LR-N07-0285

HOPE CREEK GENERATING STATION  
FACILITY OPERATING LICENSE NO. NPF-57  
DOCKET NO. 50-354

**Subject: HOPE CREEK REACTOR VESSEL (N2G) RECIRCULATION INLET  
NOZZLE SAFE-END TO NOZZLE WELD JOINT WELD NON-  
DESTRUCTIVE EXAMINATION INFORMATION**

# Evaluation of N2G 2004 Data

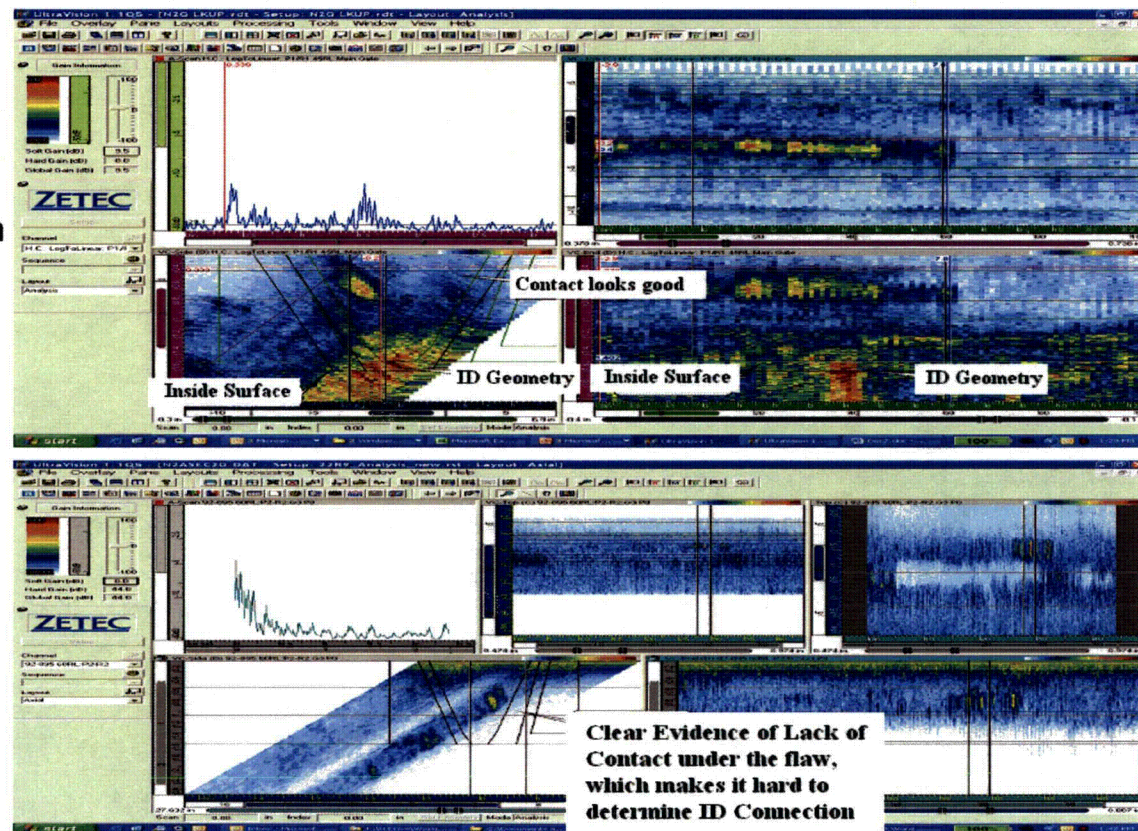
The question posed by the staff was what were the differences between the 1999/2000 N2A data and the 2004 N2G data?

- During the review of the 2004 examination data for N2G, the data collected from the nozzle side of the weld showed no issues with contact in the area of the flaw and also showed no evidence that the flaw was connected to the inside surface, unlike the data on the N2A nozzle. The data collected from the nozzle side on N2G showed that the flaw had a defined upper and lower extremity and no evidence that the data may have been compromised below it. (See figures following). The safe-end side data for N2G does not show the flaw, but the data is of reduced quality due to the effect of the crown. However, the procedure was qualified for conducting a single sided examination. The data that was collected from the nozzle side (i.e., single side) did not show evidence that it was detrimentally affected.

Data collected on  
N2G from nozzle  
side of weld

Example of  
Examination with  
Poor contact
